CONVERSION OF VISITOR SIDE PRIVATE "DRY" FIRE LINE SYSTEM TO PRIVATE "WET" SYSTEM

SITEPRO
15 Dec 2020 Submittal

SITE UTILITY PLAN
FOR
NEW PATRICK HENRY HS FIELD HOUSE AND ACCESS DRIVE
FOR
ROANOKE CITY PUBLIC SCHOOLS
PREPARED FOR
INTERACTIVE DESIGN GROUP
SITUATE 2102 GRANDIN ROAD, SW
CITY OF ROANOKE, VIRGINIA

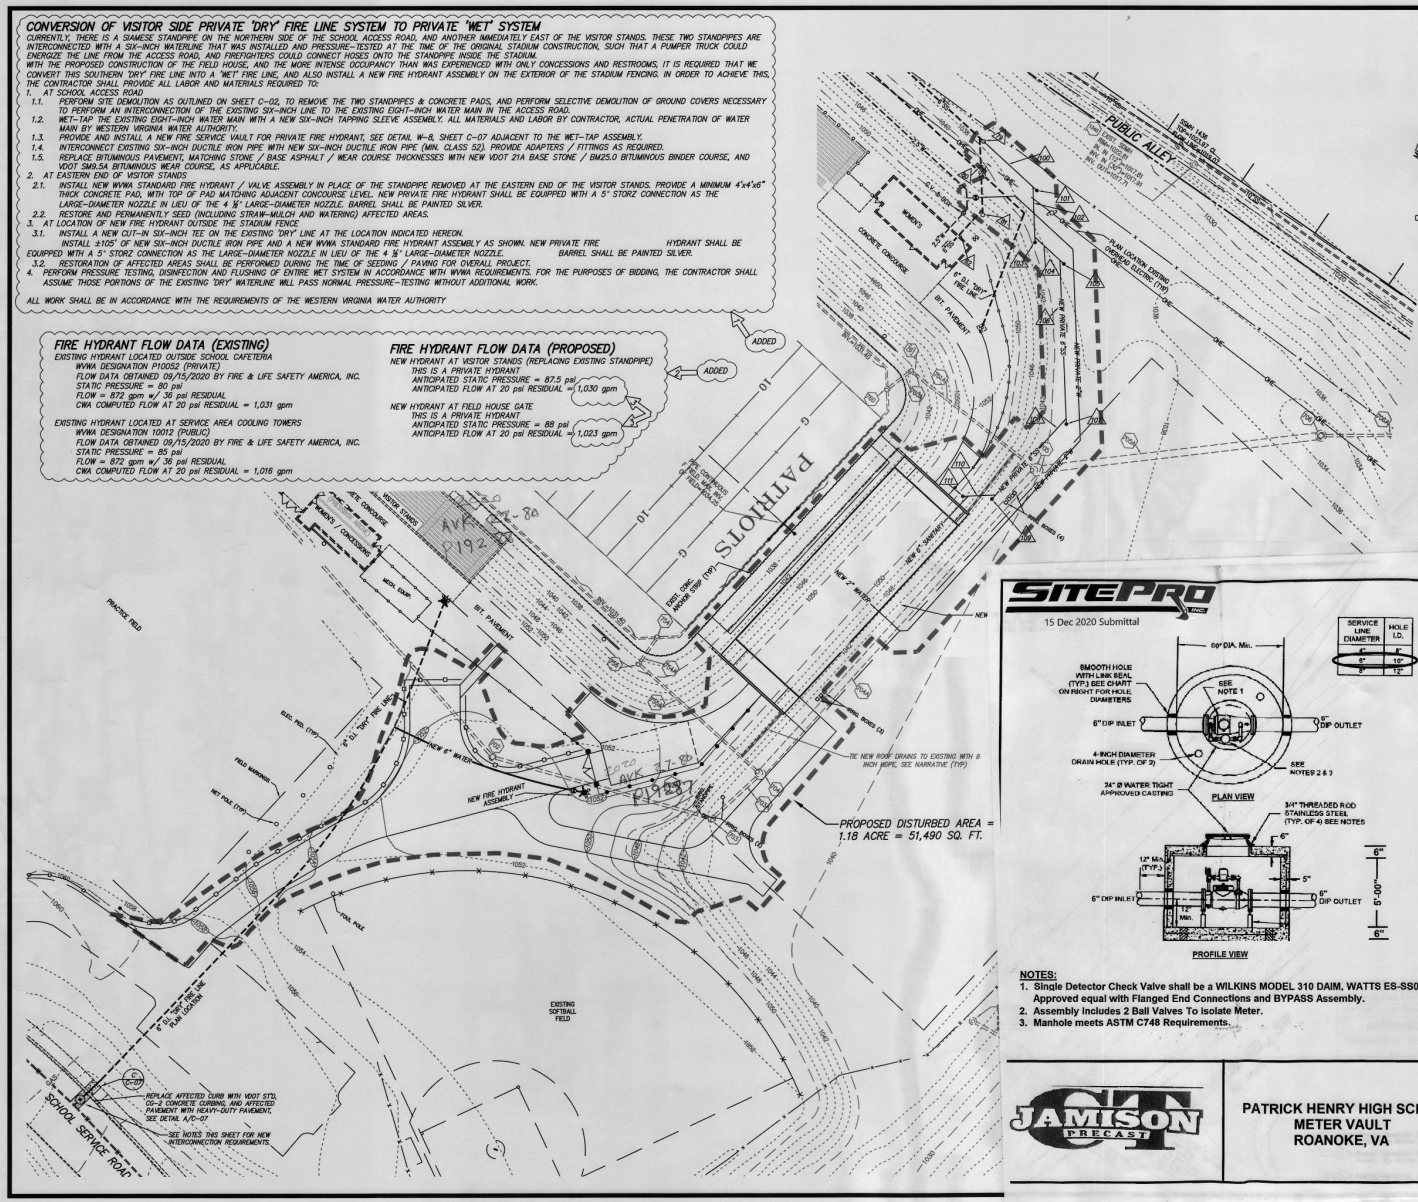
CLARIFICATION PROVIDED THAT NEW WATER & SANITARY LATERALS ARE PRIVATE

PLAN SHEET REVISED TO REFLECT THE CHANGE FROM A "DRY" STANDPIPE SYSTEM TO A "WET" SYSTEM WITH A NEW FIRE HYDRANT ASSEMBLY, AS WELL AS A NEW BRANCH 6" WATERLINE WITH NEW FIRE HYDRANT ASSEMBLY.

PLAN SHEET REVISED TO RELOCATE NEW WATER AND SANITARY LATERAL ALIGNMENTS, TO AVOID CONSTRUCTION IN THE BERM TO THE EXTENT POSSIBLE.

CURRENTLY, THERE IS A SIAMESE STANDPIPE ON THE NORTHERN SIDE OF THE SCHOOL ACCESS ROAD, AND ANOTHER IMMEDIATELY EAST OF THE VISITOR STANDS. THESE TWO STANDPIPES ARE INTERCONNECTED WITH A SIX-INCH WATERLINE THAT WAS INSTALLED AND PRESSURE-TESTED AT THE TIME OF THE ORIGINAL STADIUM CONSTRUCTION, SUCH THAT A PUMPER TRUCK COULD ENERGIZE THE LINE FROM THE ACCESS ROAD, AND FIREFIGHTERS COULD CONNECT HOSES ONTO THE STANDPIPE INSIDE THE STADIUM.

WITH THE PROPOSED CONSTRUCTION OF THE FIELD HOUSE, AND THE MORE INTENSE OCCUPANCY THAN WAS EXPERIENCED WITH ONLY CONCESSIONS AND RESTROOMS, IT IS REQUIRED THAT WE CONVERT THIS SOUTHERN "DRY" FIRE LINE INTO A "WET" FIRE LINE, AND ALSO INSTALL A NEW FIRE HYDRANT ASSEMBLY ON THE EXTERIOR OF THE STADIUM FENCING. IN ORDER TO ACHIEVE THIS, THE CONTRACTOR SHALL PROVIDE ALL LABOR AND MATERIALS REQUIRED TO:

1. AT SCHOOL ACCESS ROAD
   - 1.1. PERFORM SITE DEMOLITION AS OUTLINED ON SHEET C-02, TO REMOVE THE TWO STANDPIPES & CONCRETE PADS, AND PERFORM SELECTIVE DEMOLITION OF GROUND COVERS NECESSARY TO PERFORM AN INTERCONNECTION OF THE EXISTING SIX-INCH LINE TO THE EXISTING EIGHT-INCH WATER MAIN IN THE ACCESS ROAD.

- 1.2. WET-TAP THE EXISTING EIGHT-INCH WATER MAIN WITH A NEW SIX-INCH TAPPING SLEEVE ASSEMBLY. ALL MATERIALS AND LABOR BY CONTRACTOR, ACTUAL PENETRATION OF WATER MAIN BY WESTERN VIRGINIA WATER AUTHORITY.

- 1.3. PROVIDE AND INSTALL A NEW FIRE SERVICE VAULT FOR PRIVATE FIRE HYDRANT, SEE DETAIL W-8, SHEET C-07 ADJACENT TO THE WET-TAP ASSEMBLY.
   - 1.4. INTERCONNECT EXISTING SIX-INCH DUCTILE IRON PIPE WITH NEW SIX-INCH DUCTILE IRON PIPE (MIN. CLASS 52). PROVIDE ADAPTERS / FITTINGS AS REQUIRED.

- 3.1. INSTALL A NEW CUT-IN SIX-INCH TEE ON THE EXISTING "DRY" LINE AT THE LOCATION INDICATED HEREON. INSTALL ±105' OF NEW SIX-INCH DUCTILE IRON PIPE AND A NEW WVWA STANDARD FIRE HYDRANT ASSEMBLY AS SHOWN. NEW PRIVATE FIRE HYDRANT SHALL BE EQUIPPED WITH A 5" STORZ CONNECTION AS THE LARGE-DIAMETER NOZZLE IN LIEU OF THE 4 ½" LARGE-DIAMETER NOZZLE. BARREL SHALL BE PAINTED SILVER.
